CONSOLIDATED EDISON COMPANY OF NEW YORK, INC.
INDIAN POINT NUCLEAR GENERATING UNIT NO. 3

FIRST SUPPLEMENT TO:
PRELIMINARY SAFETY ANALYSIS REPORT

PREFACE TO QUESTIONS

Supplement 1 of the Indian Point Unit No. 3 PSAR consists of responses to the Atomic Energy Commission's letter of February 19, 1968, and July 1, 1968.

DIAGRAM OF CONTAINMENT RECIRCULATION SYSTEM
FIGURE 6-1

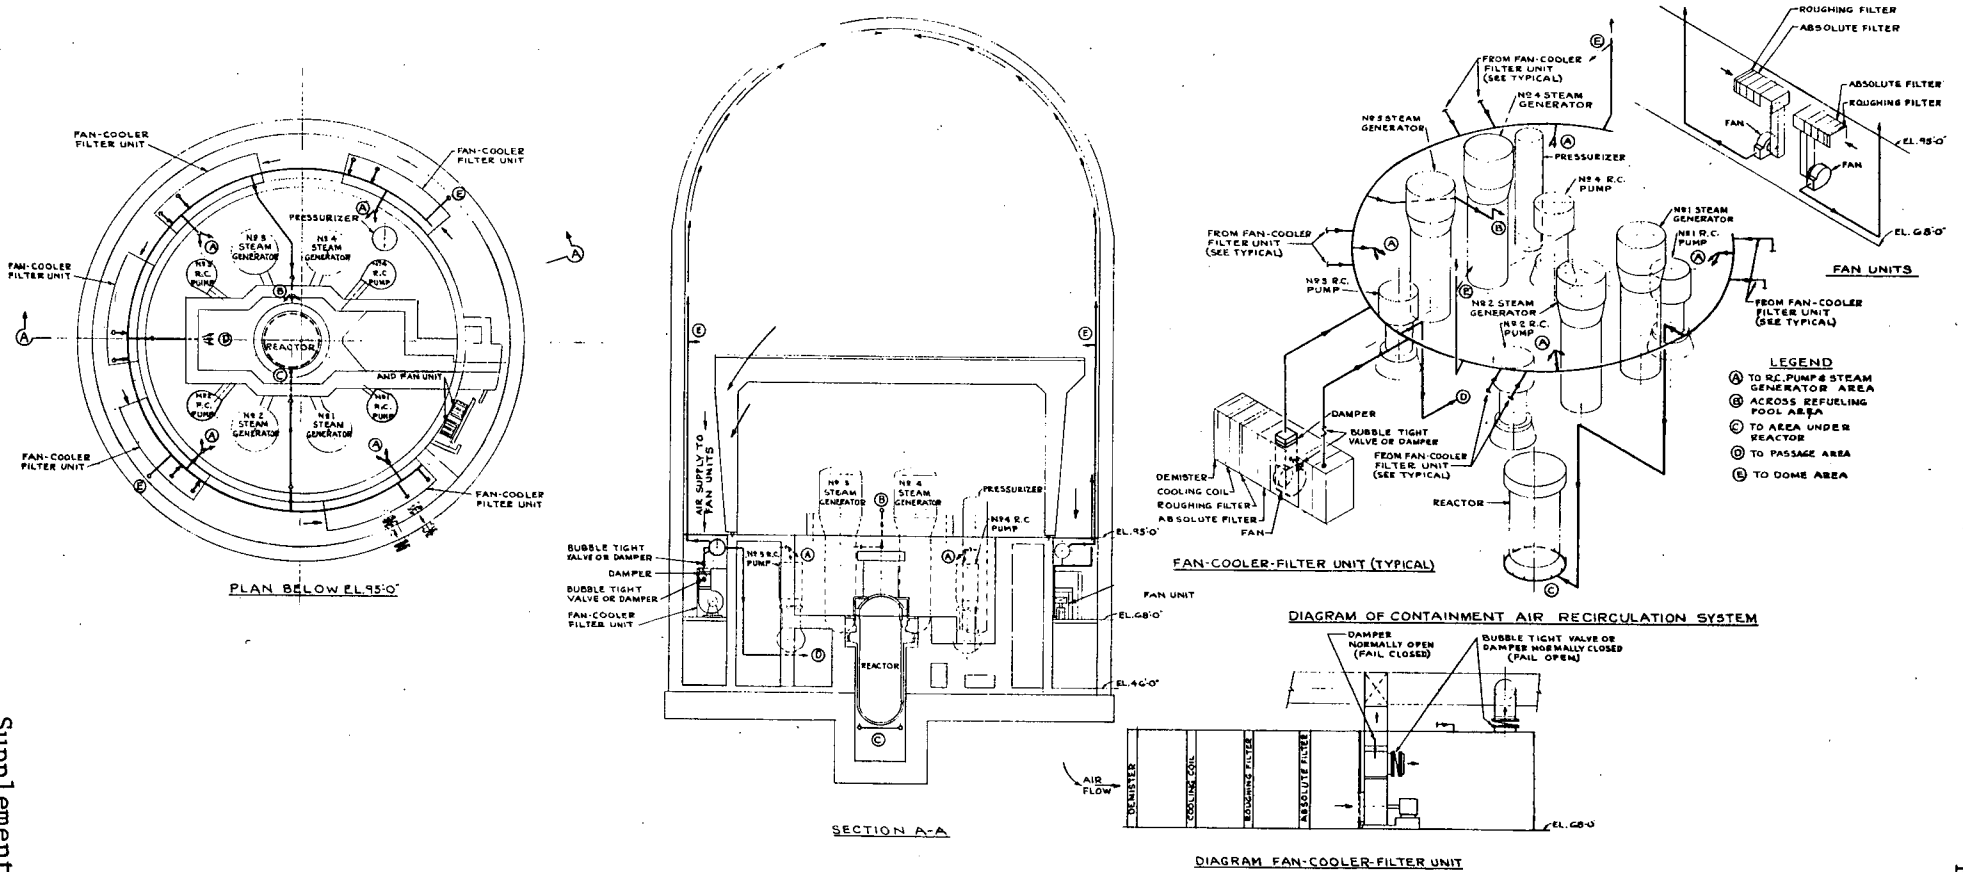
The recirculation ventilating system consists of five (5) air handling units (four of the five units will be required to operate during an accident) each supplying air to a common distribution header. Branch ducts form this header proportion and direct air to areas below and above the operating floor as required. Figure 6.1 shows the conceptual layout of the system.

FIGURE 5-1

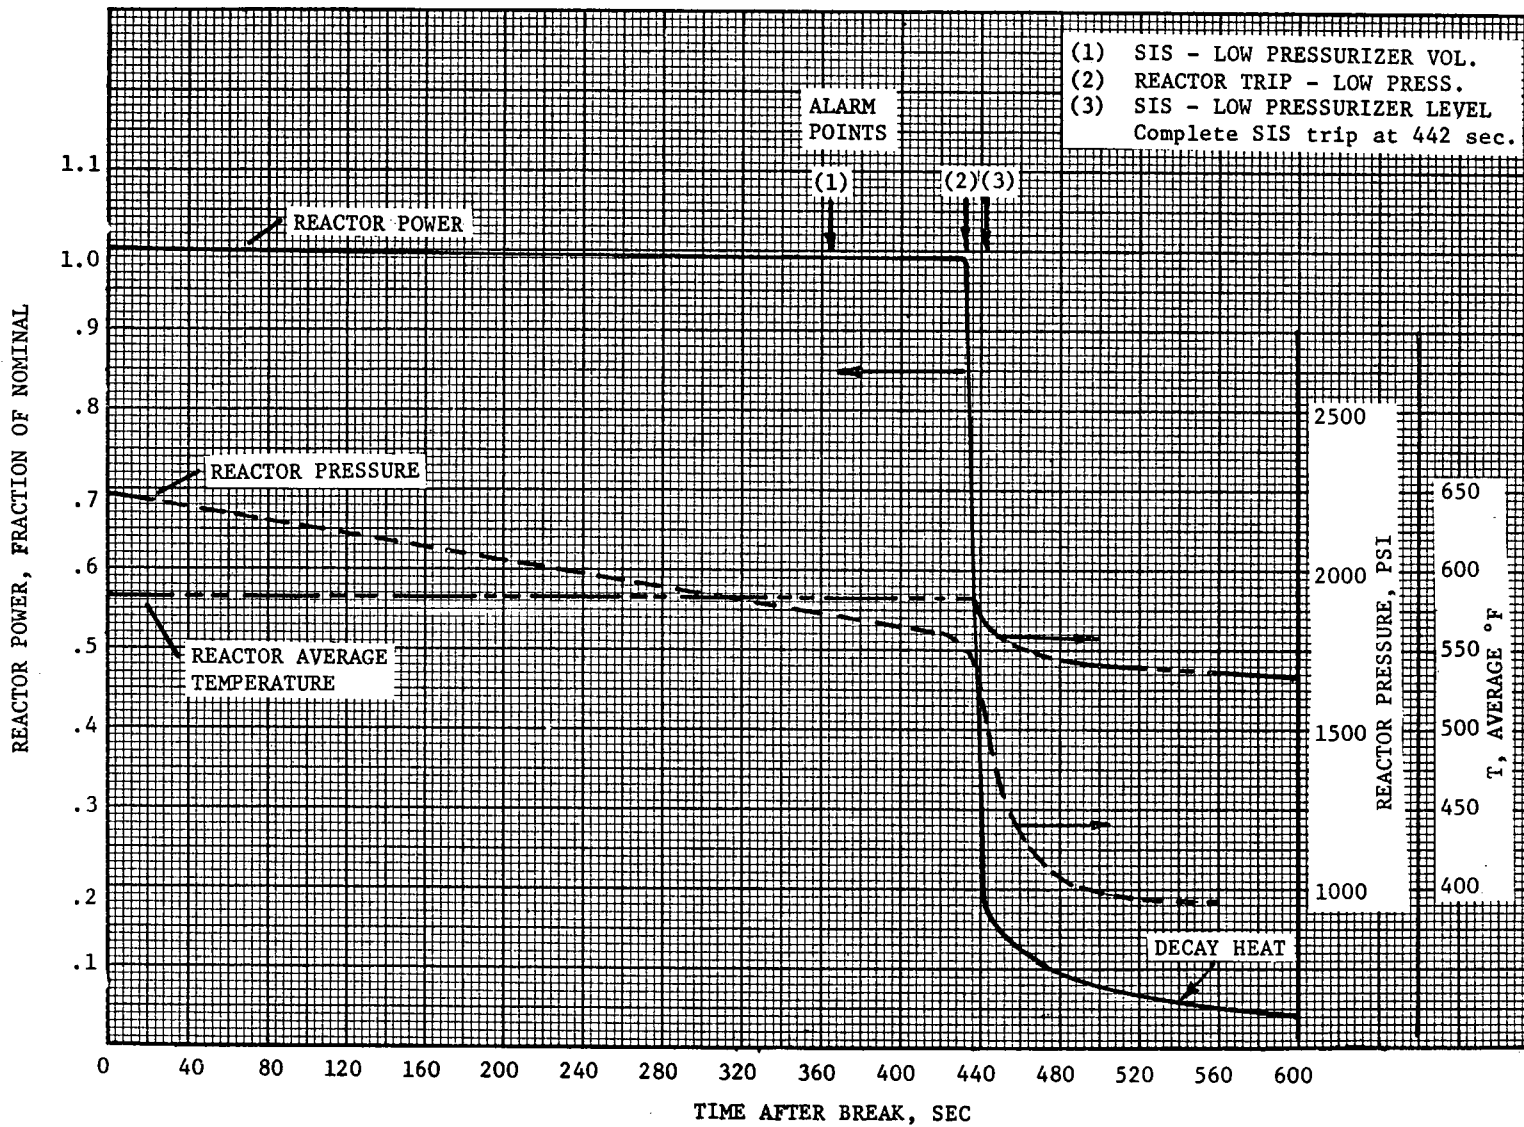
Figure 5-1 shows the power level, temperature (coolant T_{avg}) and pressure transients associated with a single tube rupture. The analysis was performed using the following assumptions:

Figure 5-2 shows the transient pressure and integrated flow through a ruptured tube over the reactor cooldown period.

The radioactivity release to the secondary plant has been evaluated consistent with the single tube rupture and failure to isolate the faulty steam generator and 1 per cent fuel defects. As shown in Figure 5-2, the total discharge from the reactor coolant to the secondary plant for these conditions is 5760 ft^3 or $163 \times 10^6 \text{ cm}^3$. The following tabulation lists the fission product concentrations for one per cent defective fuel and the resultant discharge to the secondary plant under the most adverse condition.

Item 10 (Attachment A Question 7.0)

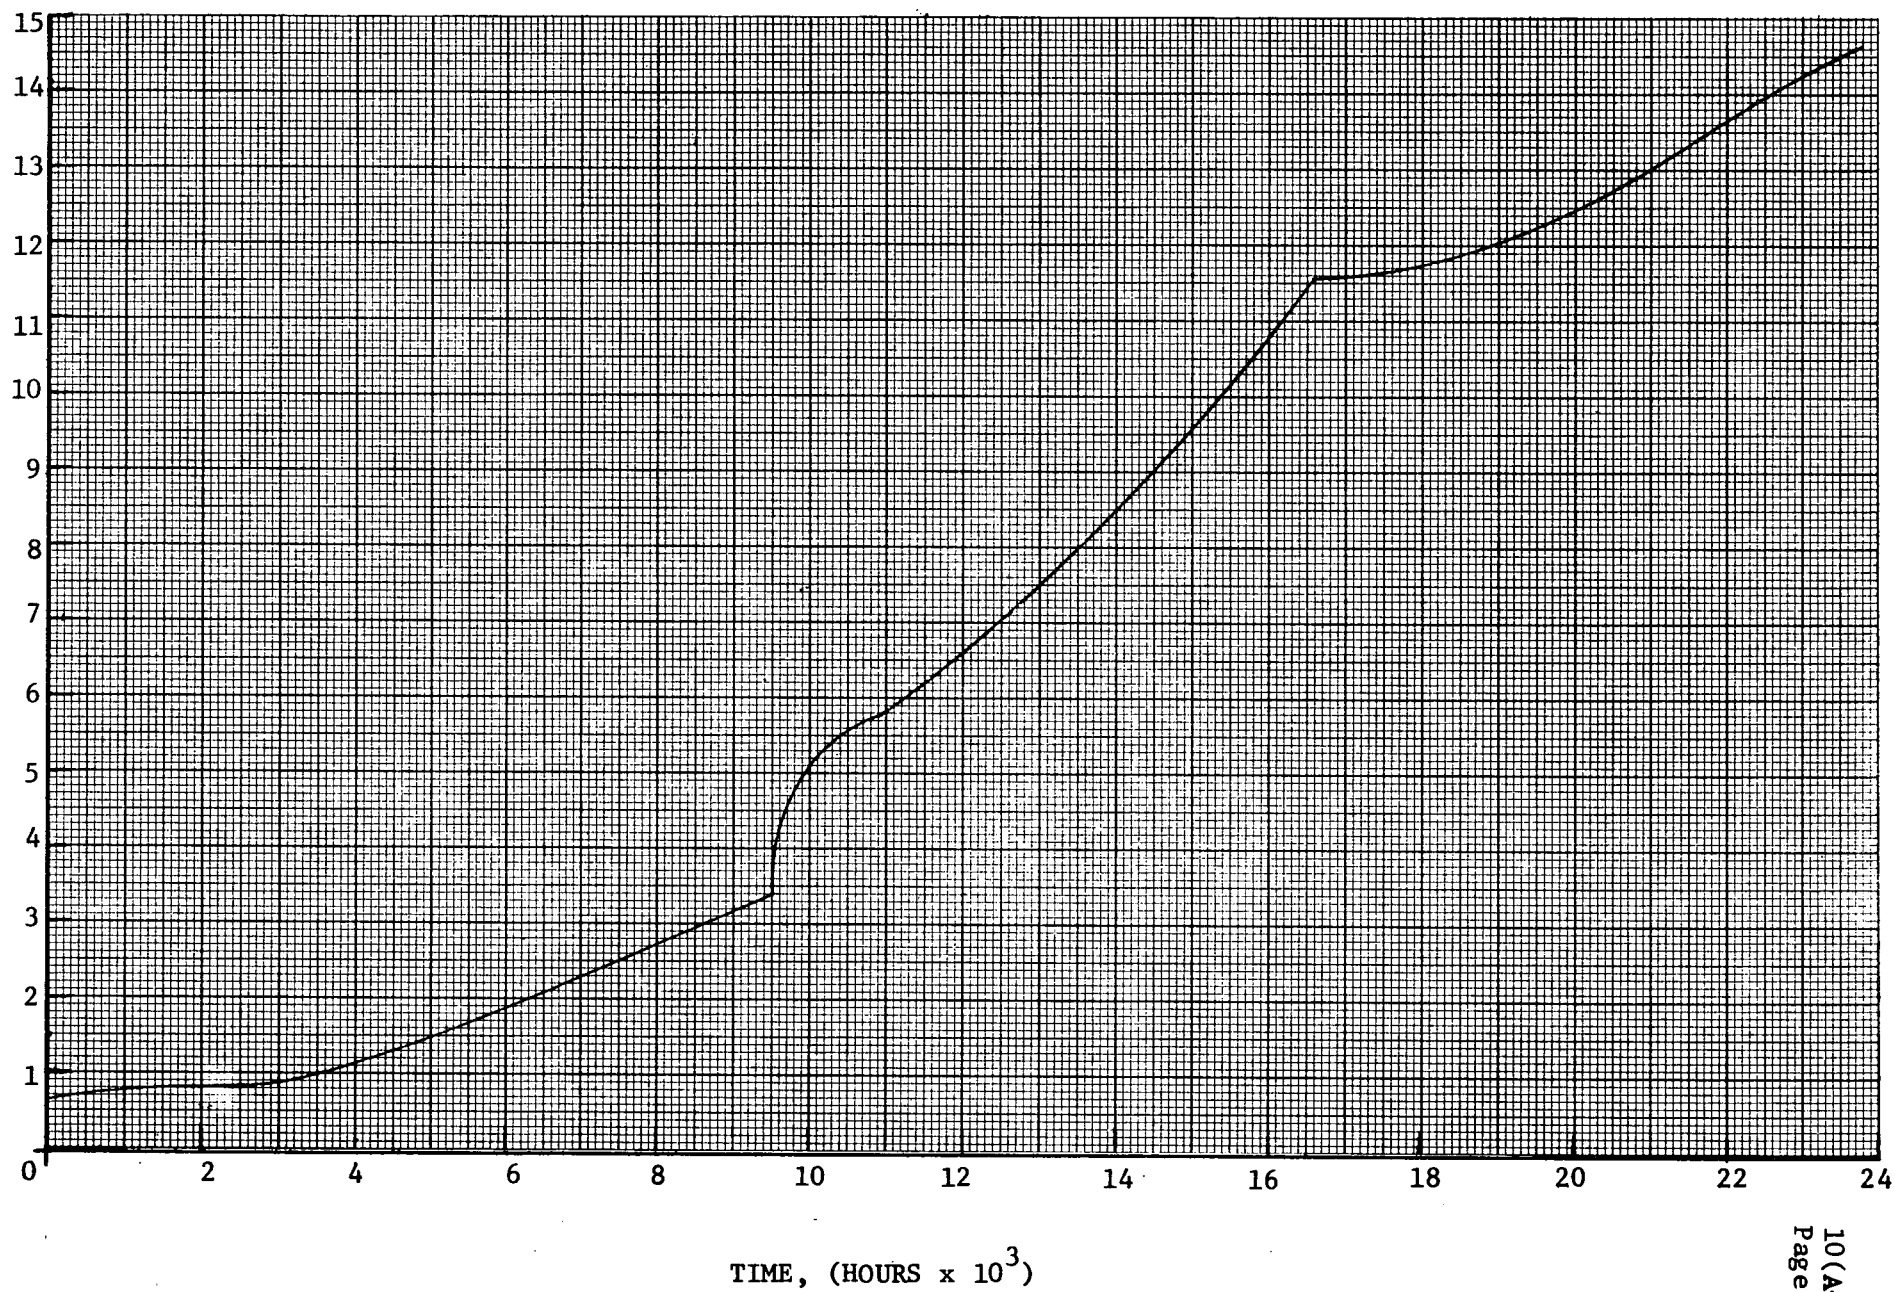
Provide the fuel pellet temperature profile and the fuel clad pressure time history used in calculating fission gas release from the fuel at the end-of-life.

AVERAGE FUEL TEMPERATURE vs. TIME

INTERNAL PRESSURE vs. TIME

FIGURE 14(C-1.2)-1

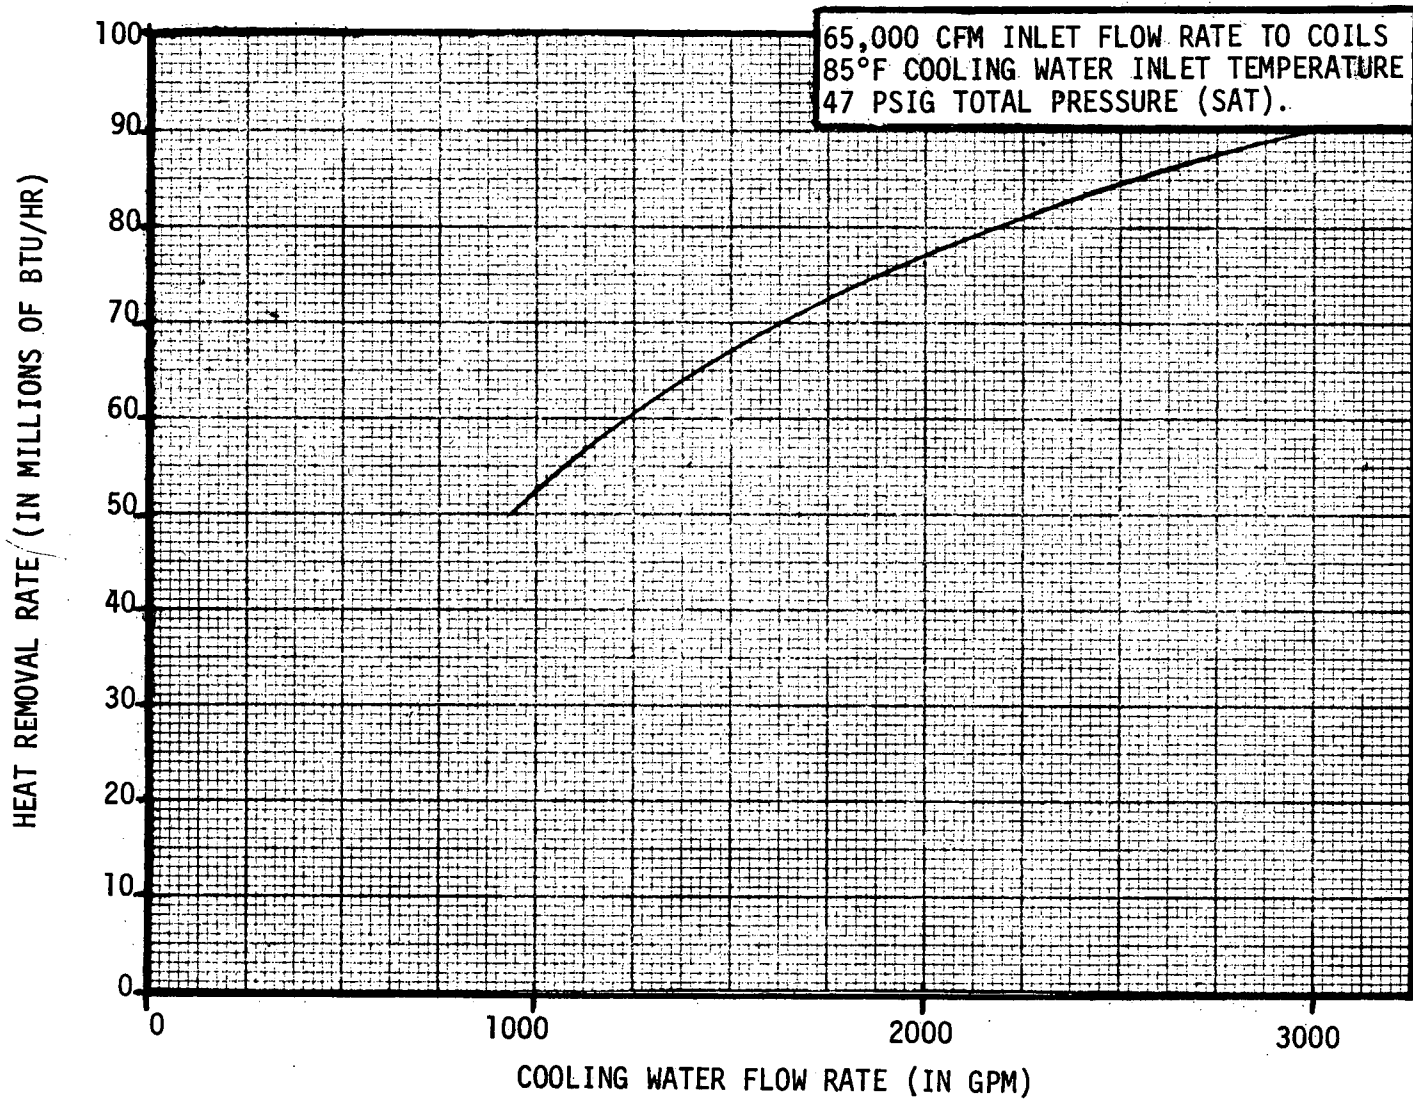
Figure 14 (C-1.2)-1 - Heat removal rate as a function of cooling water flow rate.

MASS TRANSFER-VELOCITY RATIO OF
SPRAY DROPLETS AS A FUNCTION OF
CONTAINMENT PRESSURE
FIGURE 1

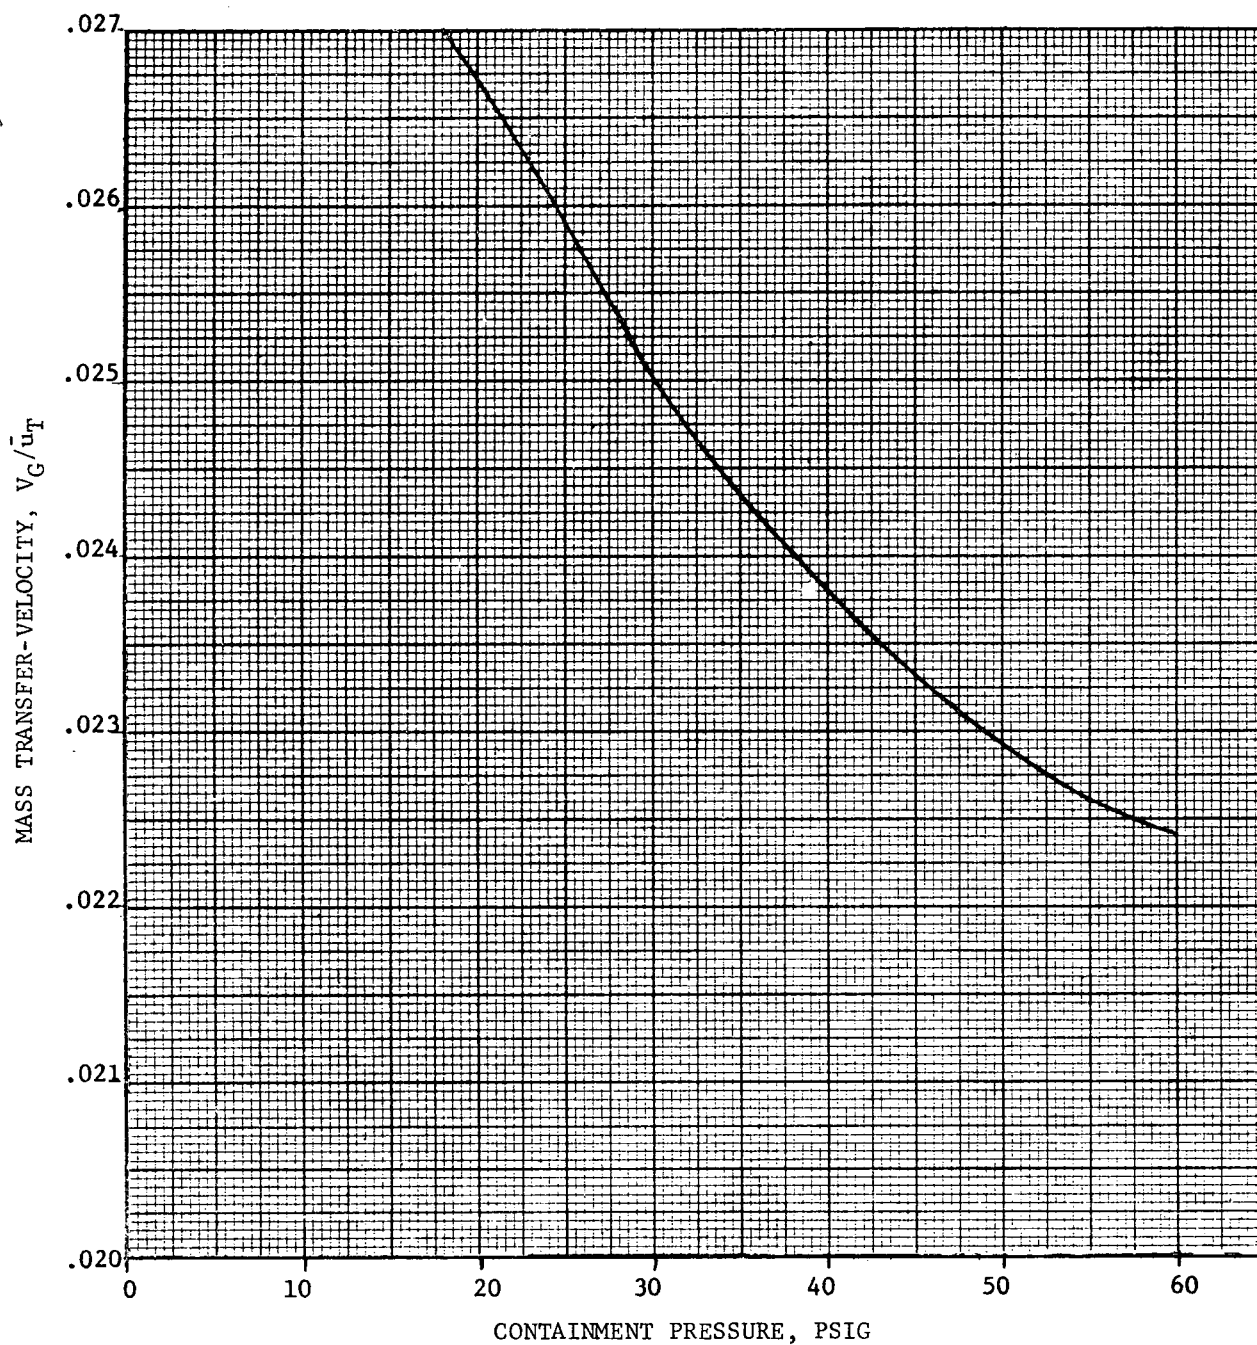
The ratio v_g/\bar{u}_t for 0.100 cm droplets in a 44 psig steam-air atmosphere, (Figure 1) is 0.0234, giving $\lambda_s = 66 \text{ hr}^{-1}$ and a half-life of 38 sec.
